**LEXINGTON-FAYETTE URBAN COUNTY
GOVERNMENT CONTRACT CHANGE ORDER**
Page 1 of 2

Date:	February 6, 2015
Project:	Senior Citizen Center Construction
Location:	Lexington
Contract No.	227-2014
Original Contract Amt.	\$8,882,900.00
Cumulative Amount of Previous Change Orders	\$138,909.67
Percent Change - Previous Change Orders	1.56%
Total Contract Amount Prior to this Change Order	\$9,021,809.67
Change Order No.	8

JUSTIFICATION FOR CHANGE

PROJECT: Senior Citizen Center Construction

SUBJECT: Bearing & Undercut

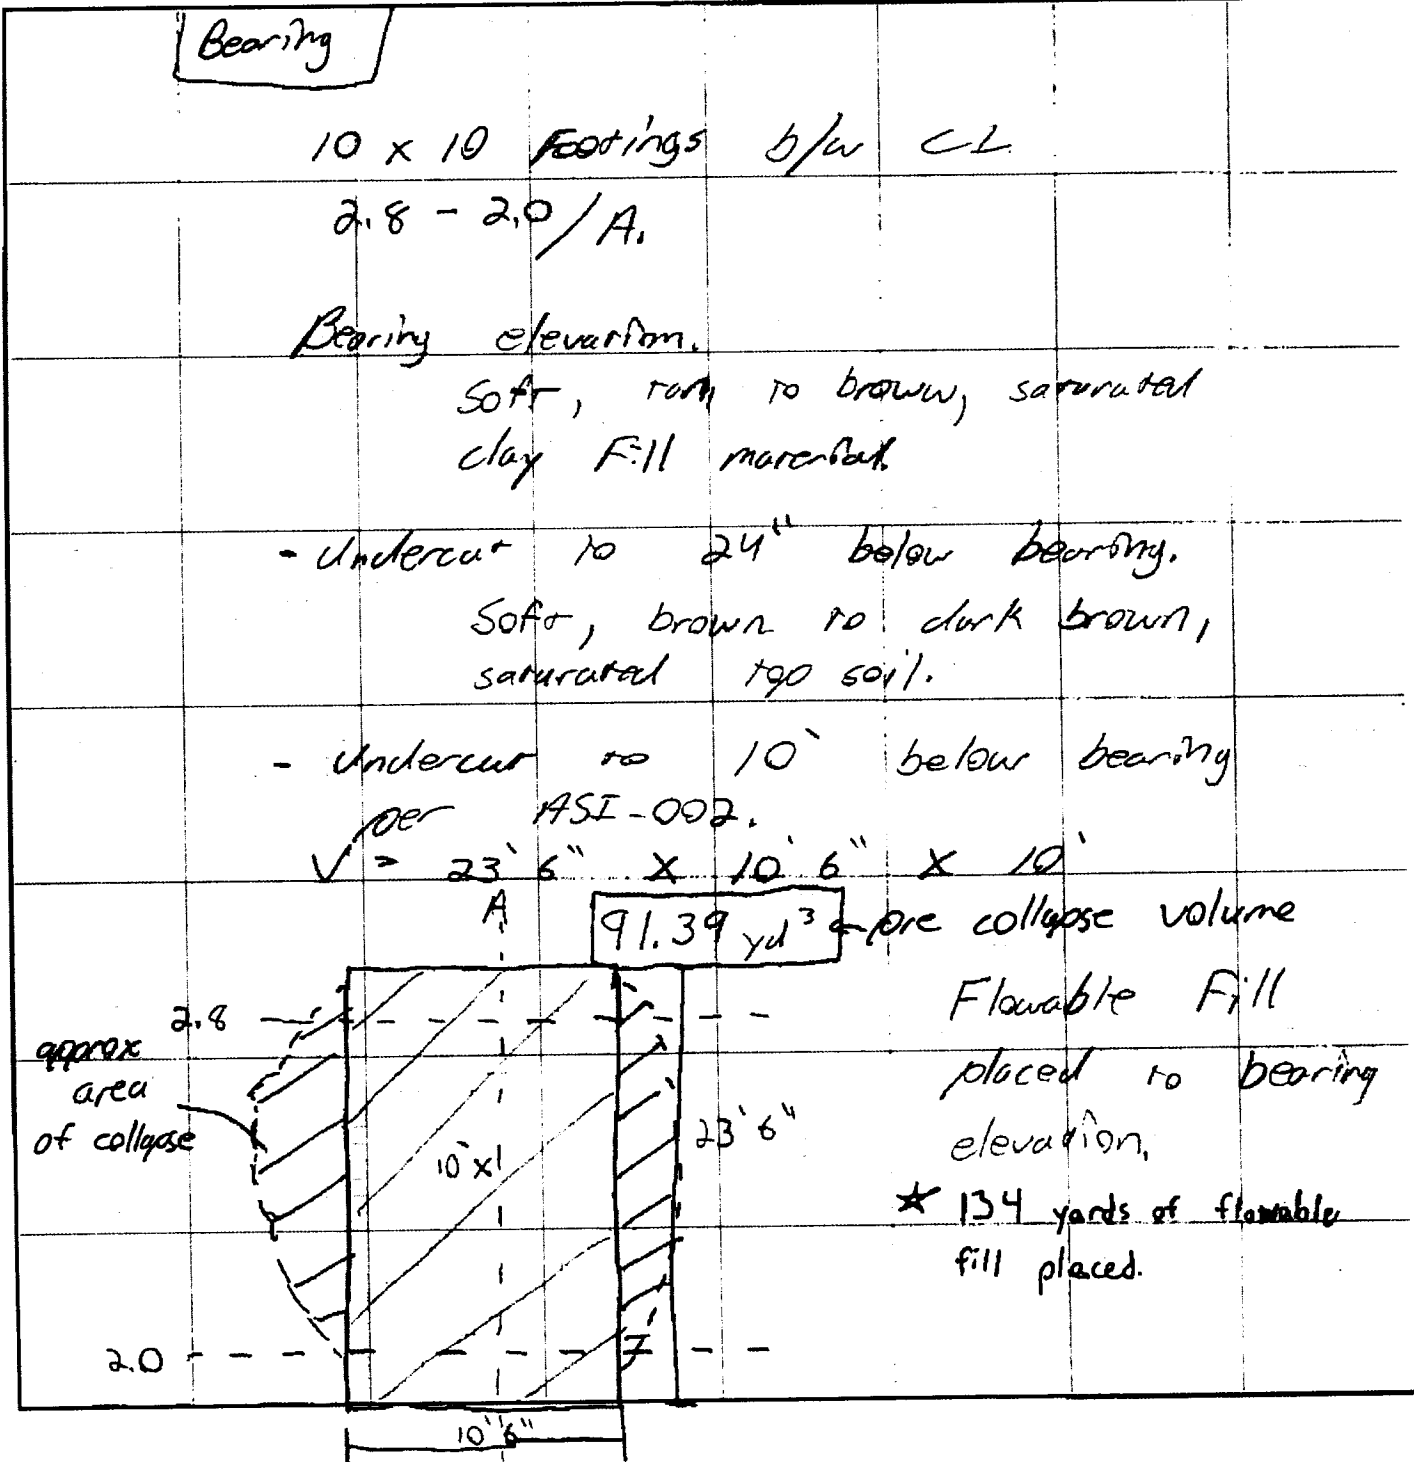
Multiple topsoil layers observed in all sides of excavation.
	Topsoil cont. to approximately 8' below bearing elevation.
	Clay pipe observed @ approx. 8' 6" below bearing.
	★ Due to both sidewalls of the excavation falling in extra allowable fill had to be placed.
	★ Due to the unstable conditions of the excavation additional measurements could not be performed.
